REVISED TECHNICAL SPECIFICATION PAGES
 FUEL CYCLE 14 OPERATION
 COOPER NUCLEAR STATION
 NRC DOCKET NO. 50-298, DPR-46

Revised Pages:	1	17	211a	212e (deleted)
	5	99	211b	212f (deleted)
	6	102	212	212g (deleted)
	7	104	212b	213
	8	210	212c	214
	12	211	212d	214b
				217

Listing of the Proposed Changes

Figure 3.11-1.1 Maximum Average Planar Linear Heat Generation Rate versus Exposure with LPCI Modification and Bypass Holes Plugged, GE8X8NB Fuel

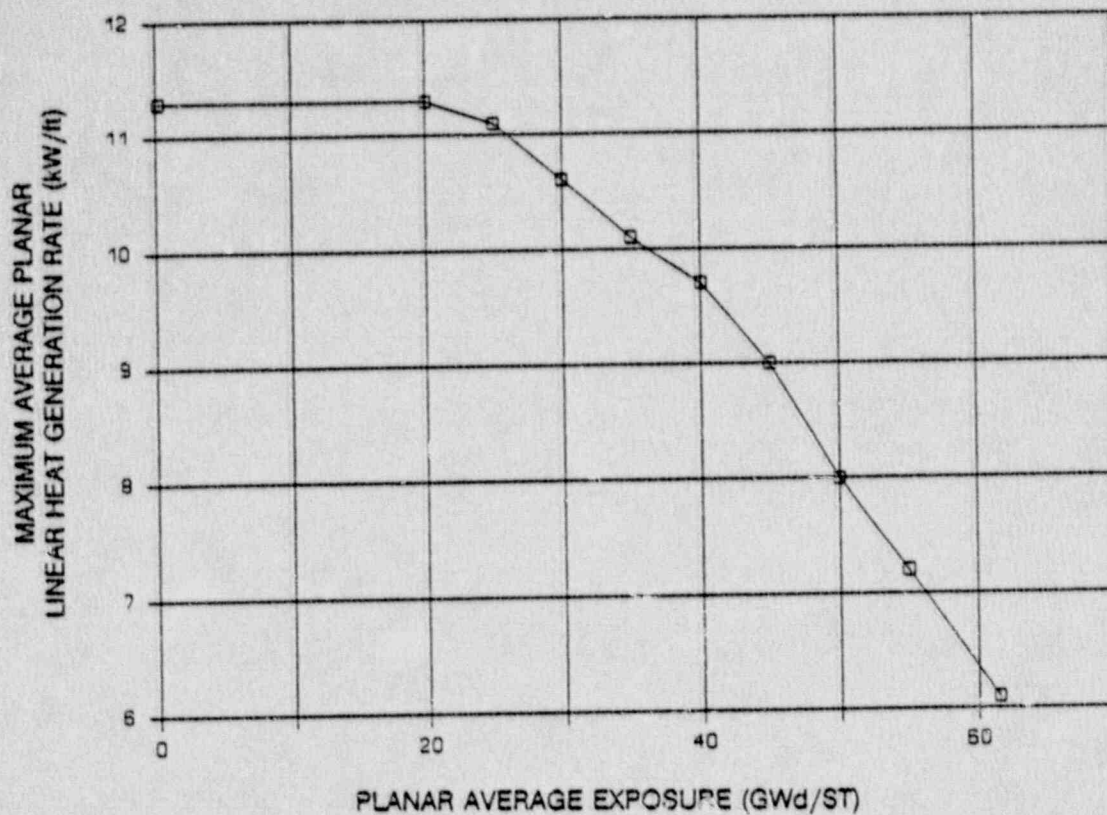
- 211 Revise Figure 3.11-1.1 to contain the MAPLHGR versus exposure curve and data coordinates for the GESX8NB fuel.

<u>GWd/ST</u>	<u>kW/ft</u>
0.2	11.07
1.0	11.26
2.0	11.49
3.0	11.73
4.0	11.90
6.0	12.23
7.0	12.41
8.0	12.61
9.0	12.80
10.0	12.93
12.5	12.93
15.0	12.69
20.0	12.02
25.0	11.35
45.0	7.12
50.6	5.92
51.3	5.80

Figure 3.11-1.3 Maximum Average Planar Linear Heat Generation Rate versus Exposure with LPCI Modification and Bypass Flow Holes Plugged, P8DRB265L and BPCDRB265L Fuel and 1988 LTA.

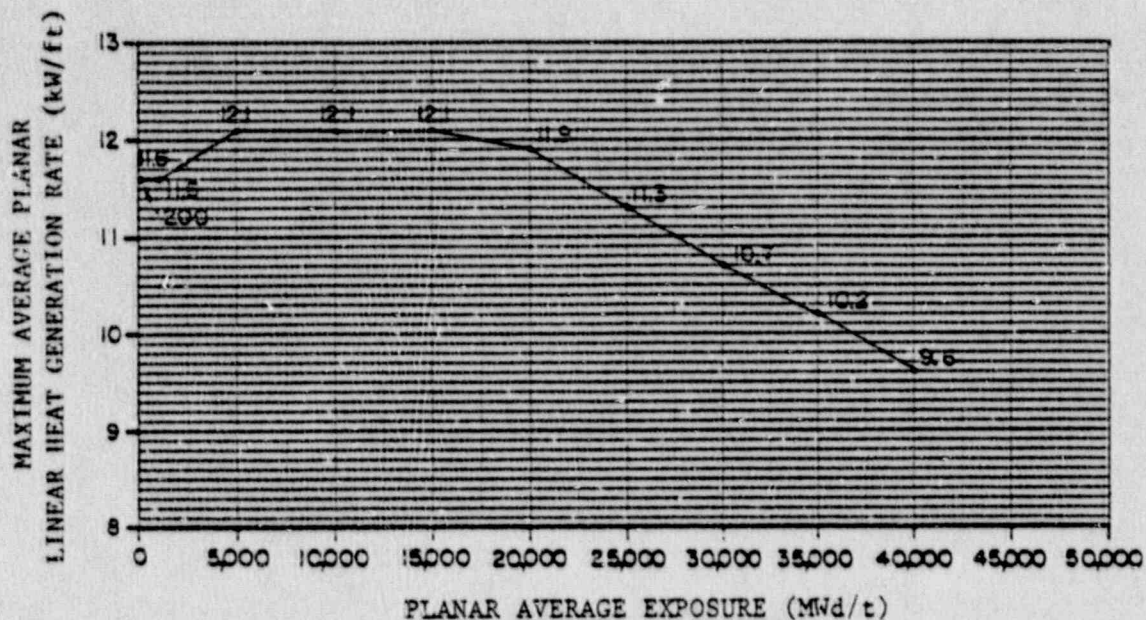
- 211b Renumber the figures to 3.11-1.3 and 3.11-1.4 and revise the title of the upper figure to include the 1988 LTA fuel.

Figure 3.11-2a GE8X8NB Fuel (BOC to EOC)

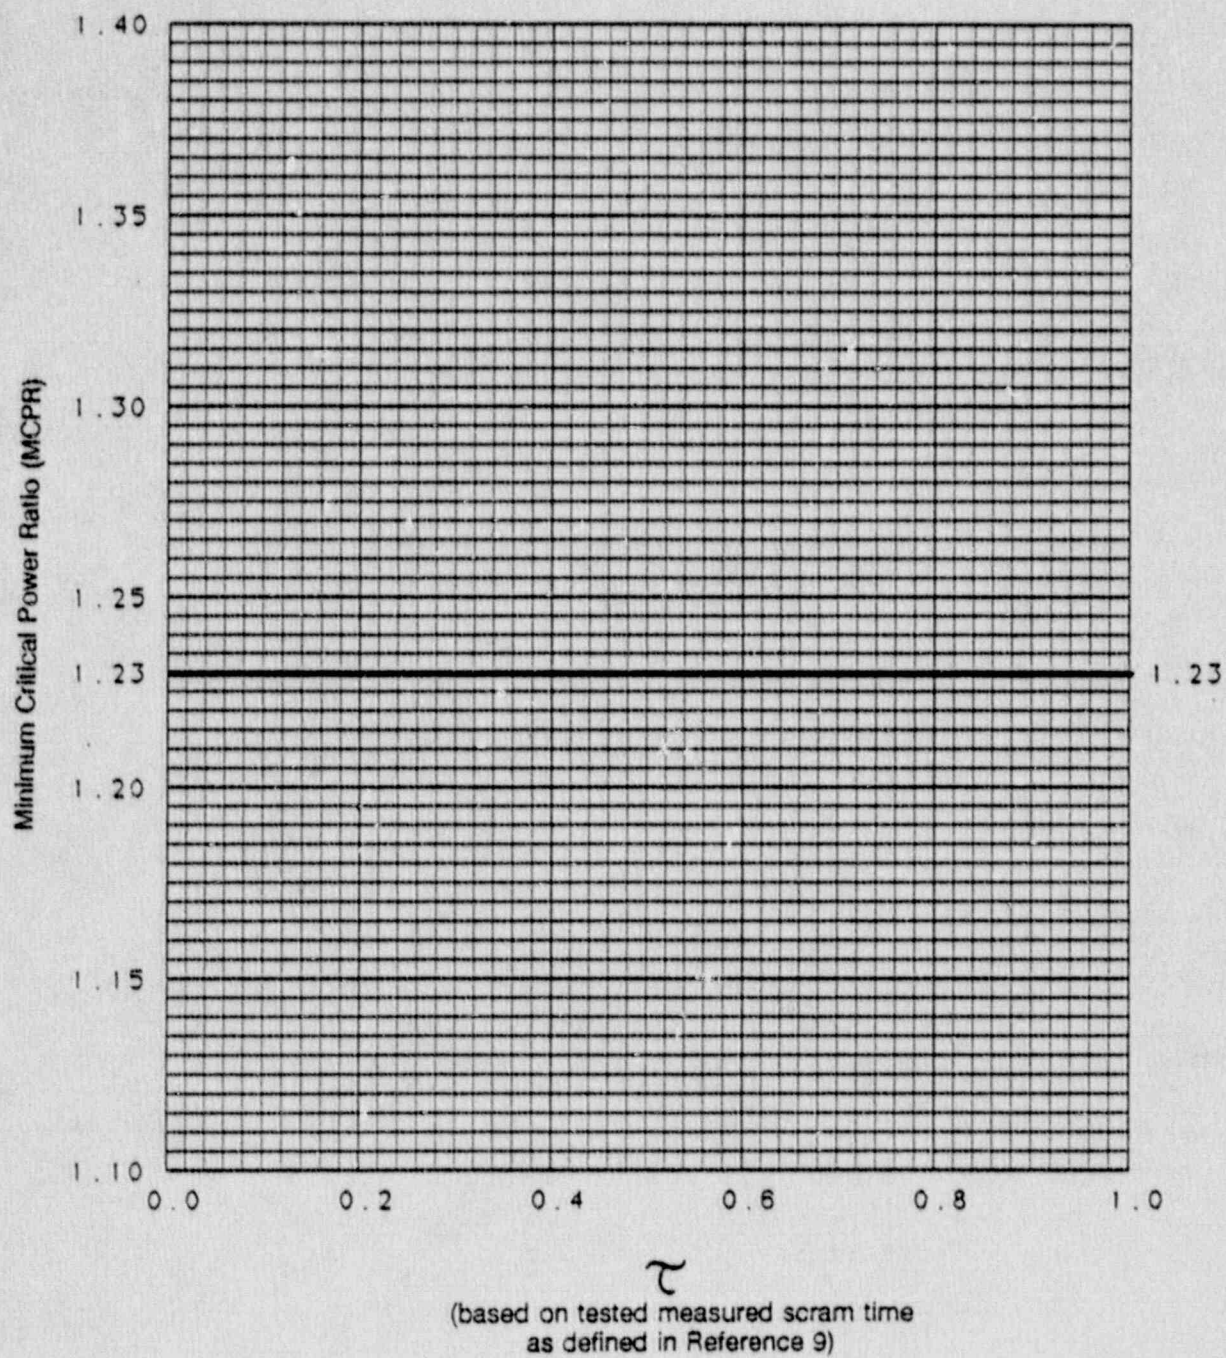
- 212b Revise Figure 3.11-2a to provide the MCPR curve for the GE8X8NB fuel for Cycle 14 operation.

Figure 3.11-2b GE11 LTA Fuel (BOC to EOC)

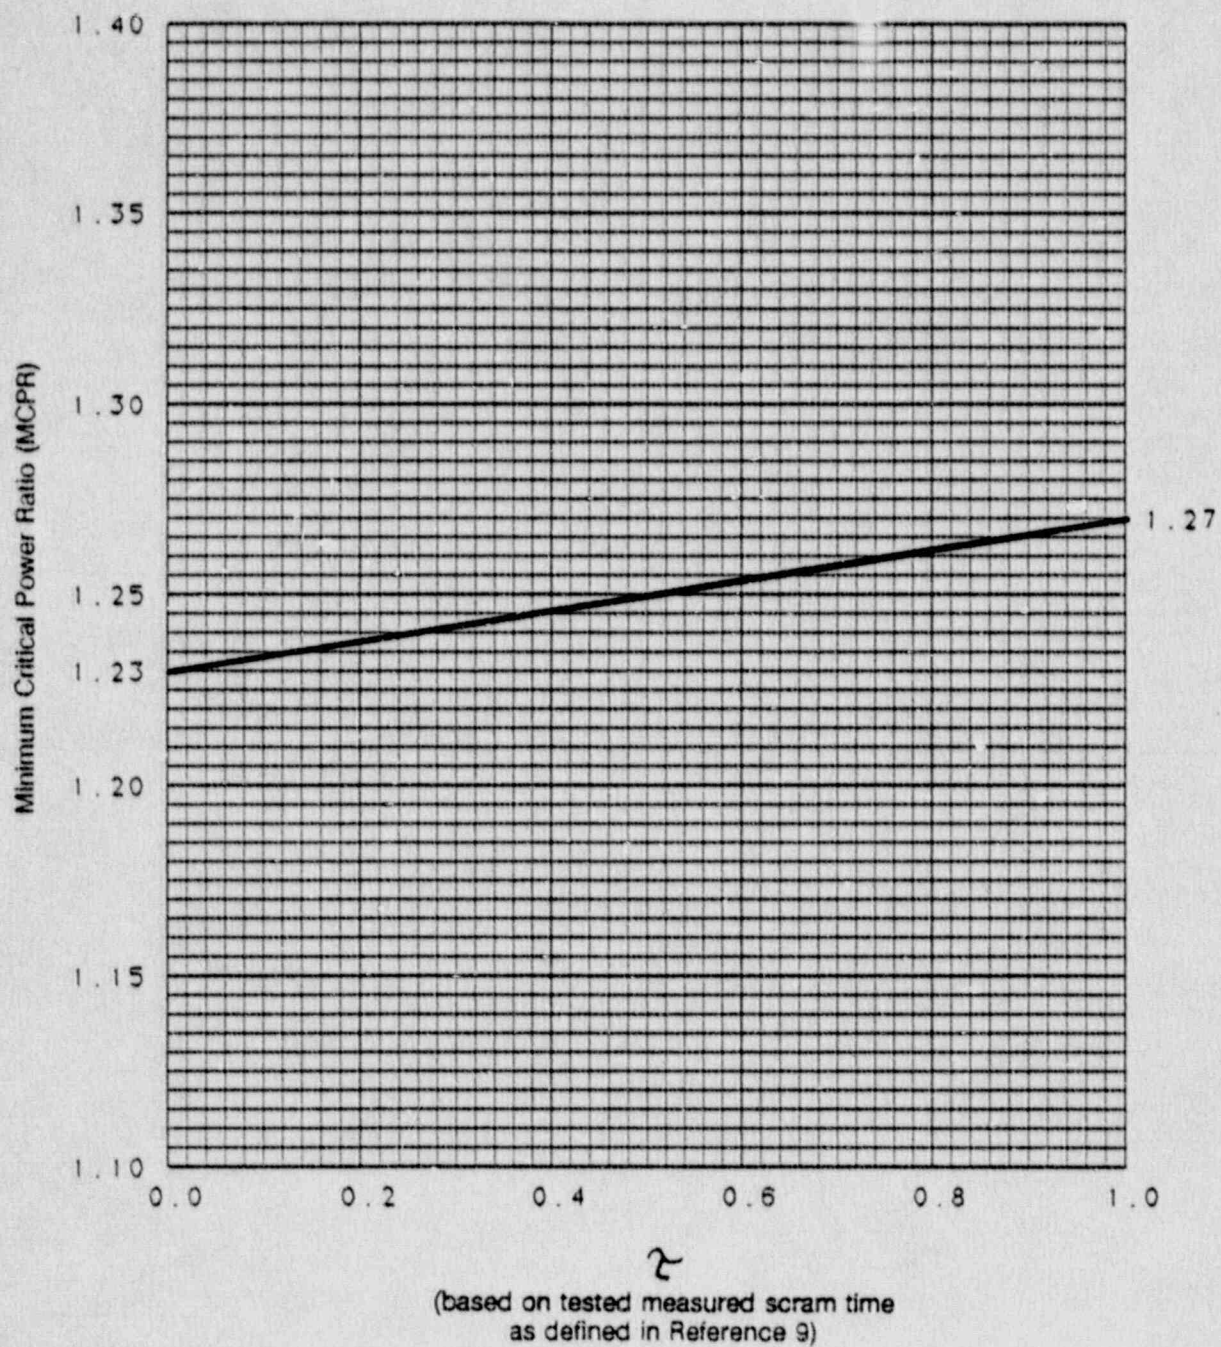
- 212c Revise Figure 3.11-2b to provide the MCPR curve for the GE11LTA fuel for Cycle 14 operation.

Figure 3.11-2c BP8X8R and 1988 LTA Fuel (BOC to EOC)

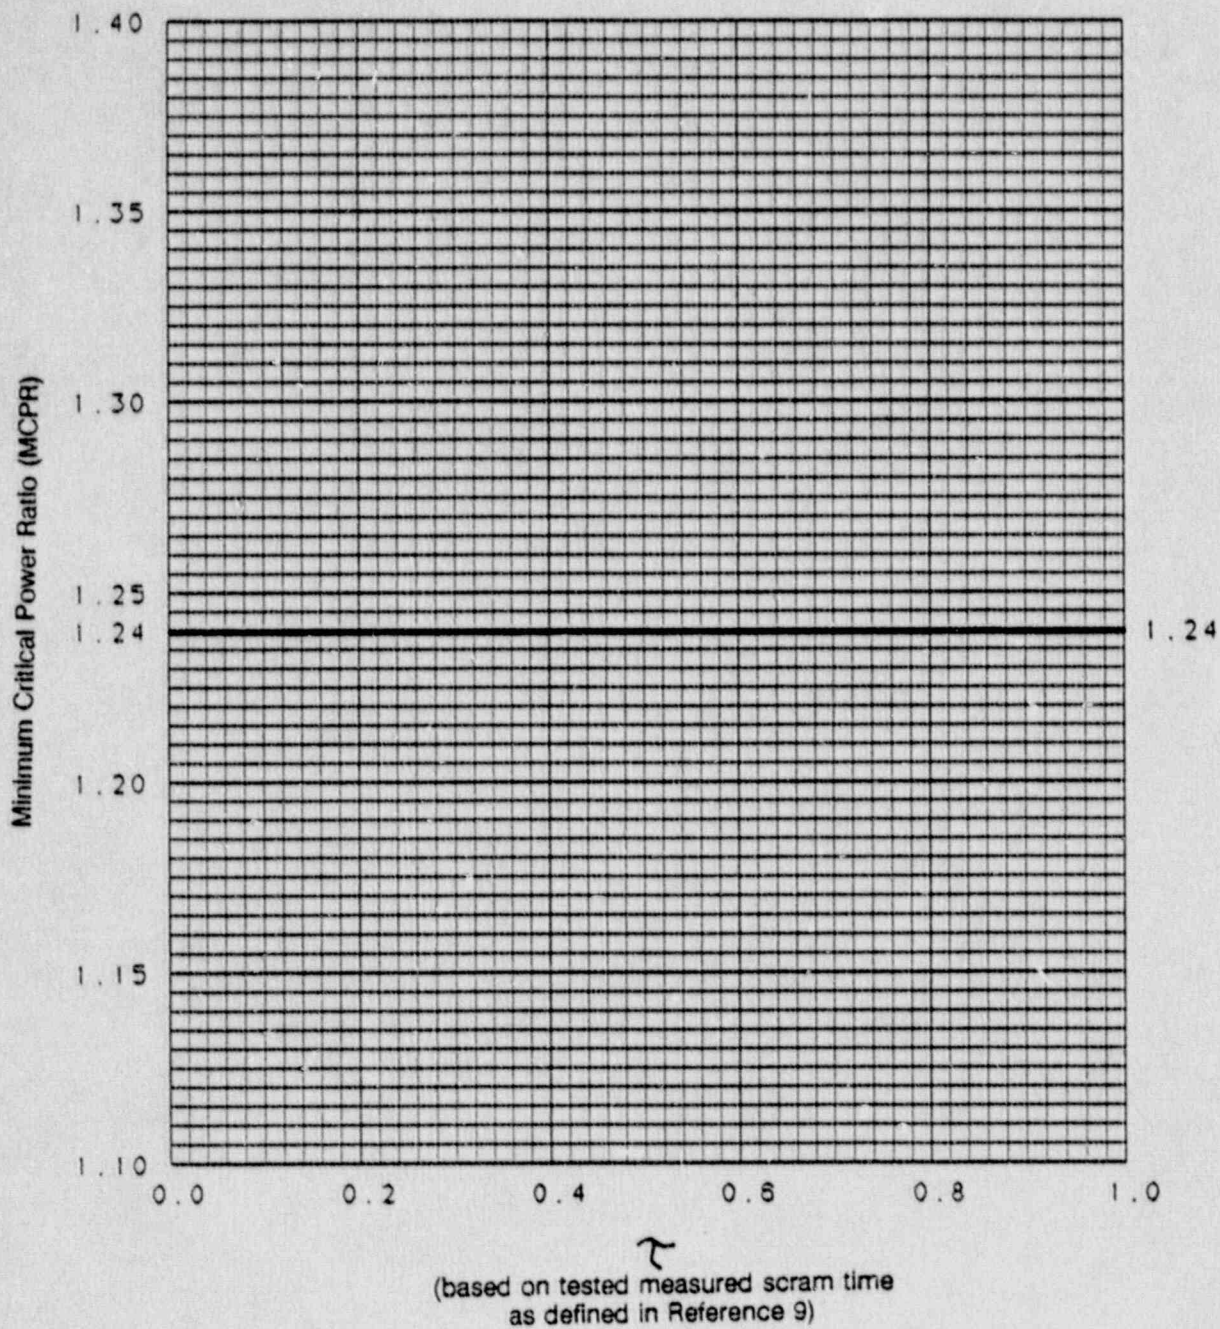
- 212d Revise Figure 3.11-2c to provide the MCPR curve for the BP8X8R and 1988 LTA fuel for Cycle 14 operation.
